# SERVICE BULLETIN

SERVICE BULLETIN NO: 180

## FLIGHT CONTROLS - HORIZONTAL STABILIZER - INSTALLATION OF A TRIM WARNING SYSTEM

Revision 1 to this Service Bulletin adds and corrects part numbers and revises the installation/ test procedure.

Lighted Switch (Warning Annunciator) DS100 Installation  
Figure 4

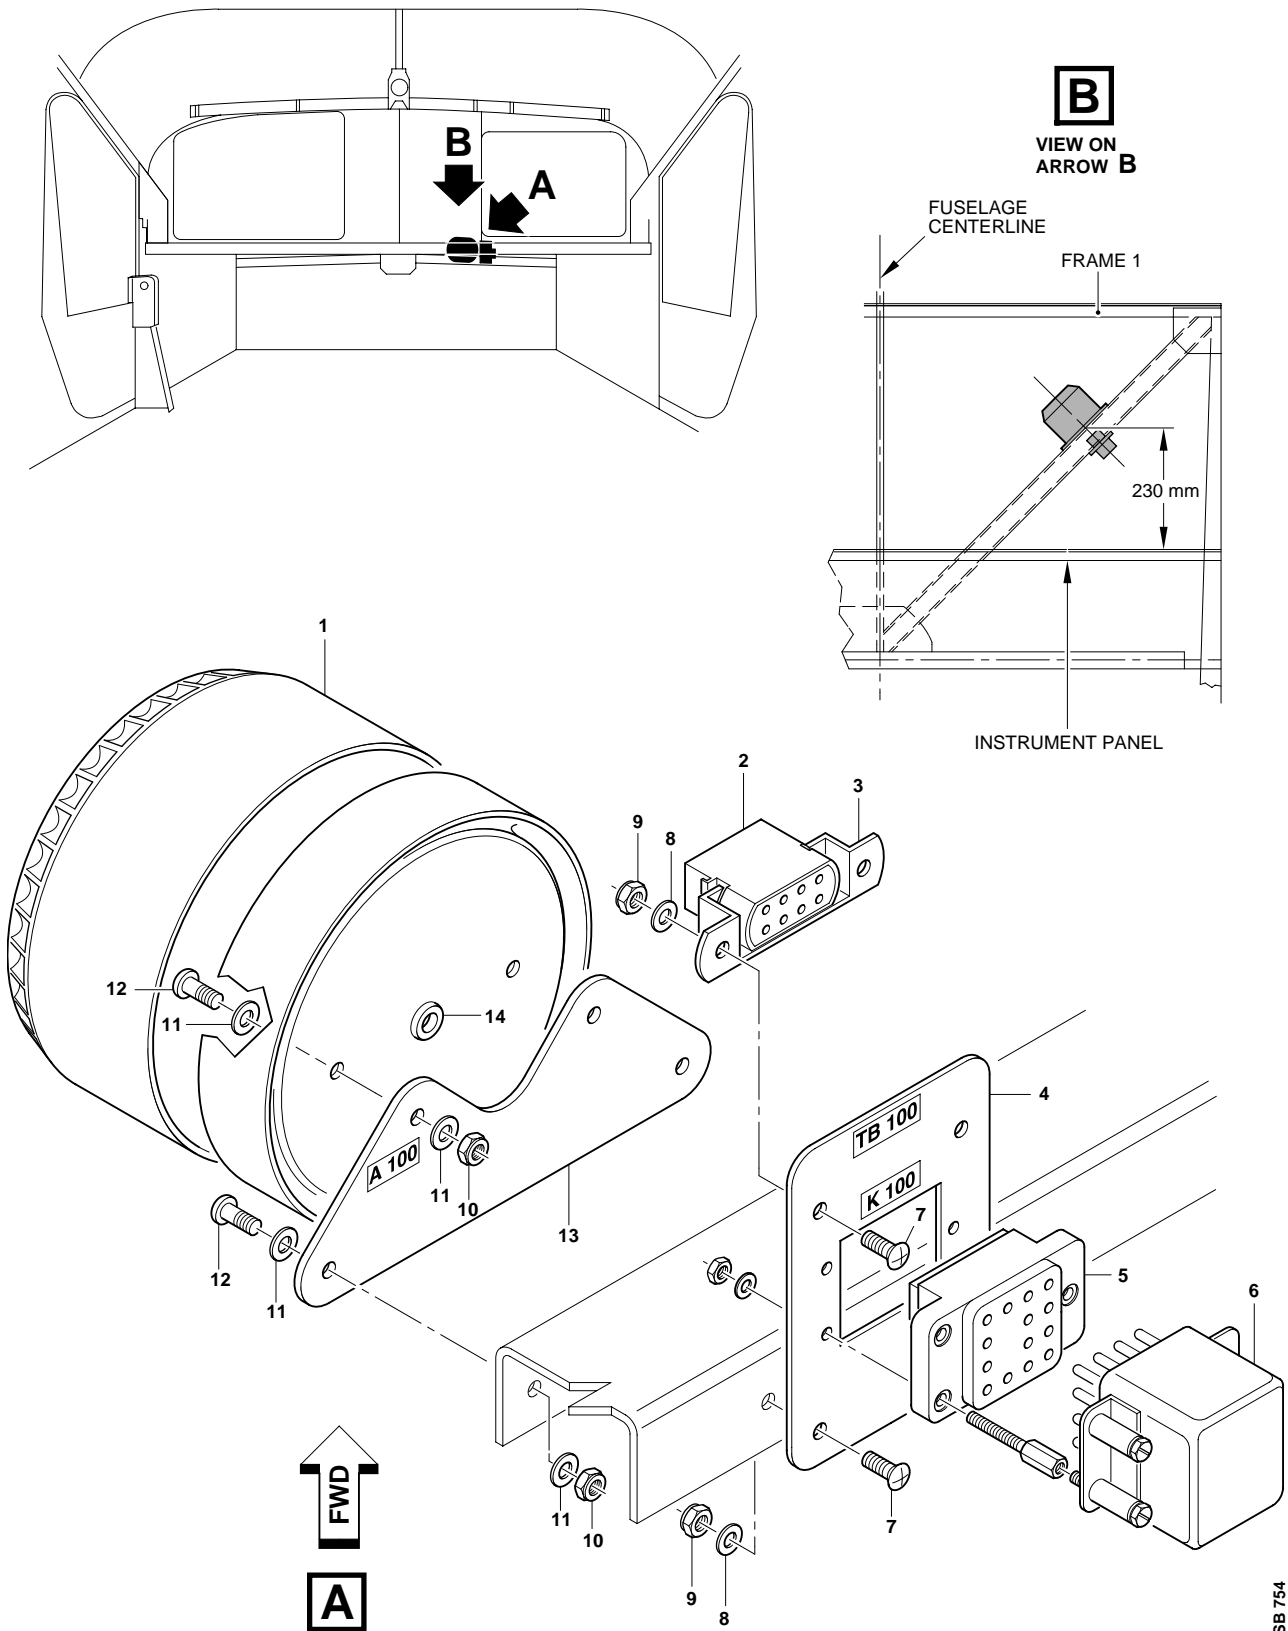
- (13) Install the lighted switch DS100 (Ref. Fig. 4).
  - (a) Put a cover over the local area to keep out unwanted material.
  - (b) Put the support bracket (2) in position.
  - (c) Mark the locations for the two 4.3 mm holes on the support bracket of the stand-by magnetic compass.
  - (d) Drill the two 4.3 mm holes.
  - (e) Install the DS100 placard on the lighted-switch support bracket (2).
  - (f) Attach the support bracket (2) to the support bracket of the stand-by magnetic compass with the two screws (3), the two washers (4) and the two nuts (5).
  - (g) Install the lighted switch DS100 (1) in the support bracket (2).
  - (h) Remove the cover and the unwanted material.

- (14) Install the lighted switch DS100 (1) in a spare lighted switch location (Ref. Fig. 4).
- (15) Install the DS100 placard behind the panel adjacent to the switch.

CB Box and CB100 Installation  
Figure 6

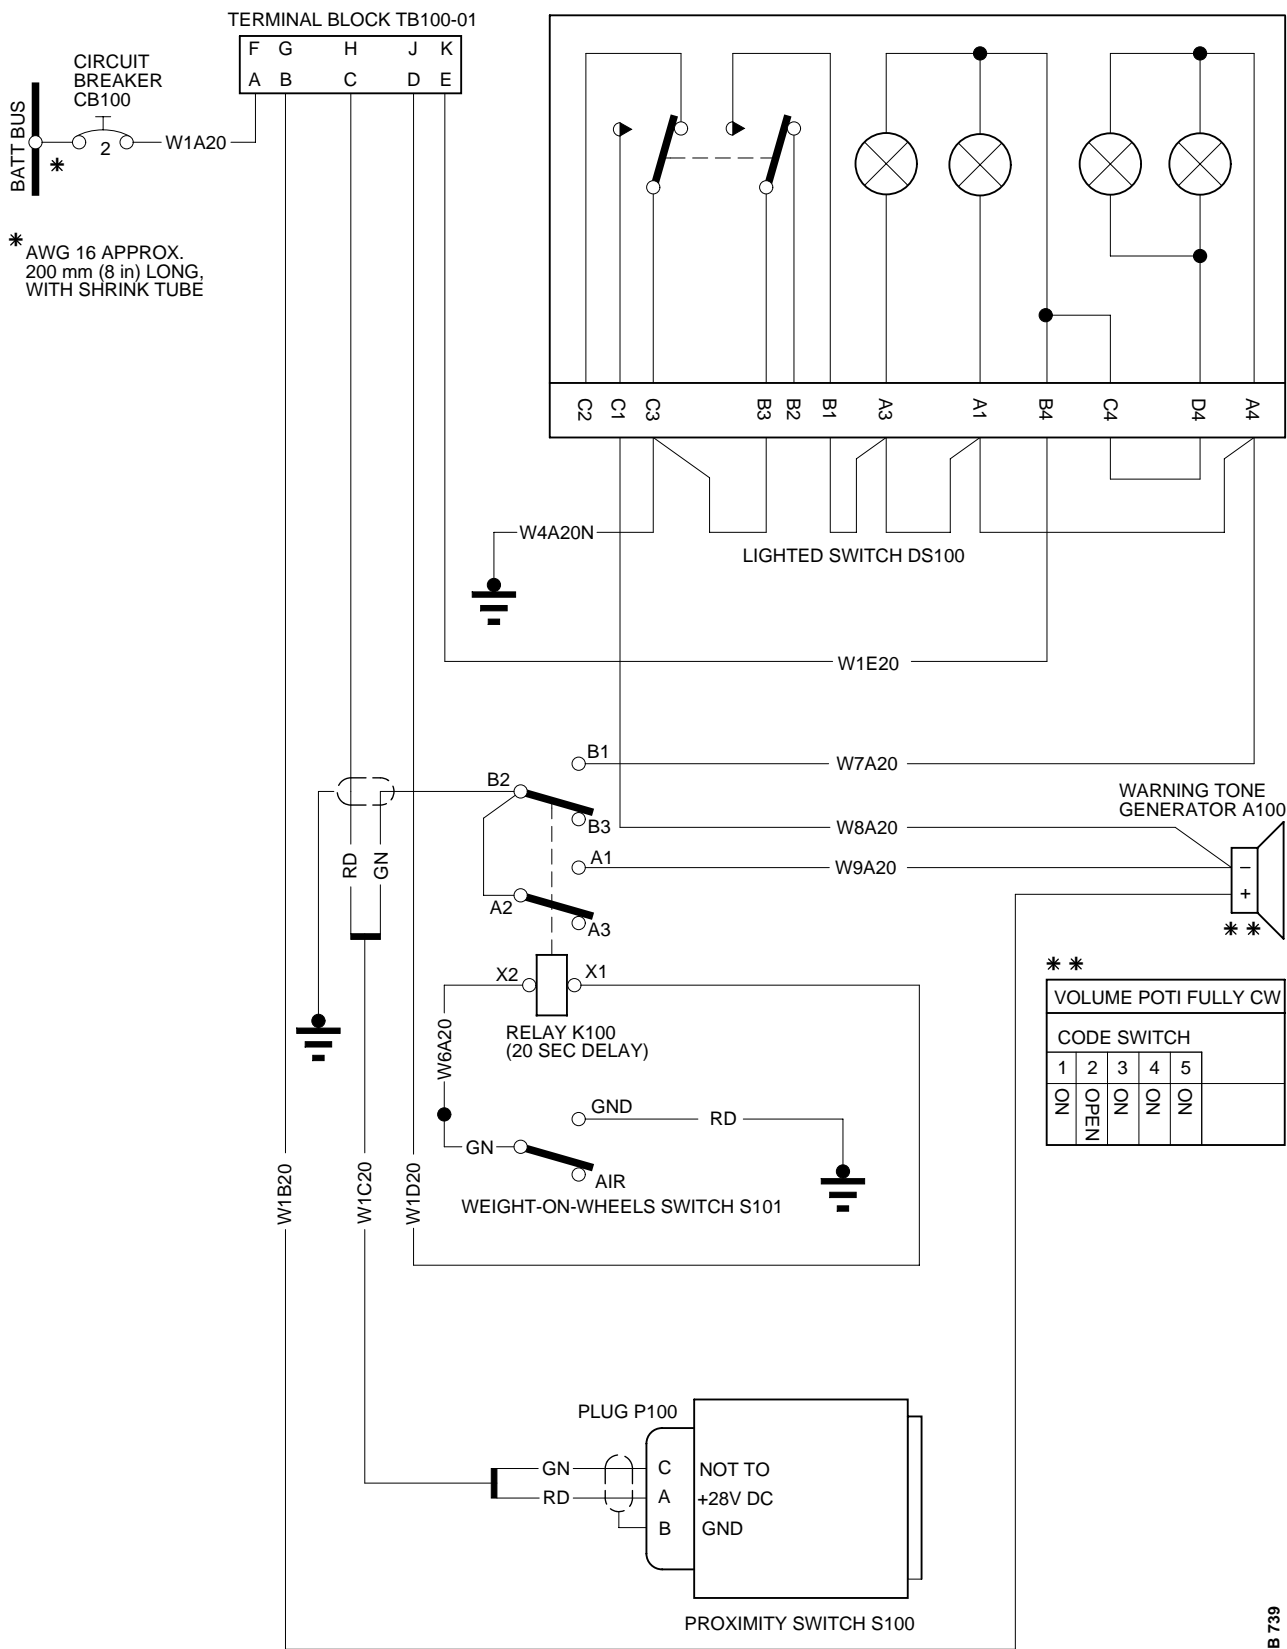
- (17) Install the circuit breaker CB100 as follows (Ref. Fig. 6):

**NOTE:** If the top of the left circuit-breaker (CB) box assembly has been used to mount another item. Install the CB box (2) on the RH CB box assembly or use a spare CB location and discard the CB box (2).

- (a) Temporarily release the fasteners and move the CB panel away from the box assembly as much as possible, but do not put a strain on the wires
- (b) Put a cover over the local area to keep out unwanted material.
- (c) Put the CB box (2) in position (approximately center if possible) on the top of the CB box assembly.
- (d) Mark the locations for the four 4.1 mm holes on the top of the CB box assembly.
- (e) Drill the four 4.1 mm holes.
- (f) Install the CB100 placard on the side of the new CB box.
- (g) Install the TRIM WARN placard below the circuit breaker CB100 placard.
- (h) Attach the CB box (2) to the CB box assembly with the four screws (3), washers (4) and nuts (5).
- (i) Install the CB100 (1) in the CB box (2).
- (j) Attach the CB panel to the box assembly with the fasteners.
- (k) Remove the cover and unwanted material.

- (l) Make sure that there is no metal swarf remaining near the CB electrical connections.
- (18) Install the CB100 (1) in a spare CB location.
- (19) Install the CB100 and TRIM WARN placards behind the panel adjacent to CB100 (1).
- NOTE:** Step 18 thru step 19, is only applicable to aircraft which do not have a circuit breaker box assembly on the LH or RH side of the cockpit.
- (20) Install the wiring (Ref. Fig. 7):
- (a) To install the wiring related to the electrical items of the horizontal stabilizer trim warning-system, use the table that follows:.

Aircraft with Mechanical Actuator for Horizontal Stabilizer Trim - Recommended Cable Clamps  
Figure 9

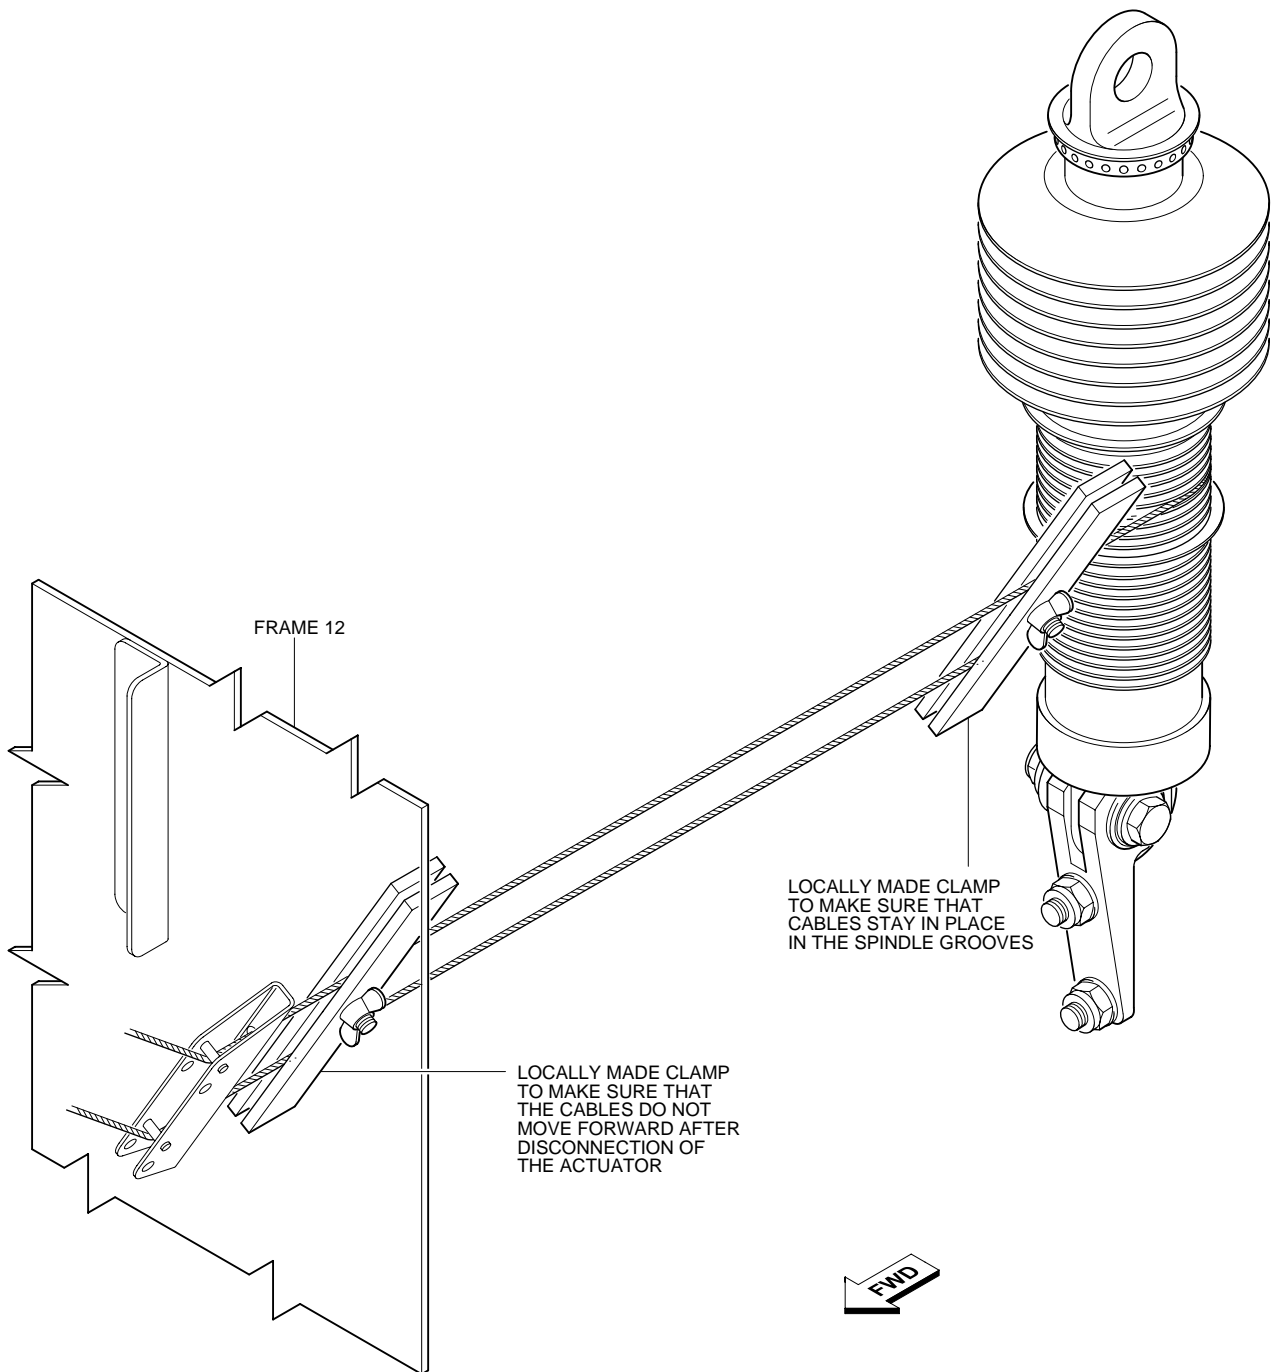
- (a) Remove access panel FL2 (Ref. AMM Chapter 06-40-00).
- (b) Install two locally-made clamps on the trim actuator cables, make sure that one touches the actuator and the other one touches the rear of Frame 12 (Ref. Fig. 9).

**NOTE:** This is to hold the actuator cables in their grooves. It stops forward movement of the cables after the horizontal stabilizer is disconnected from the actuator.
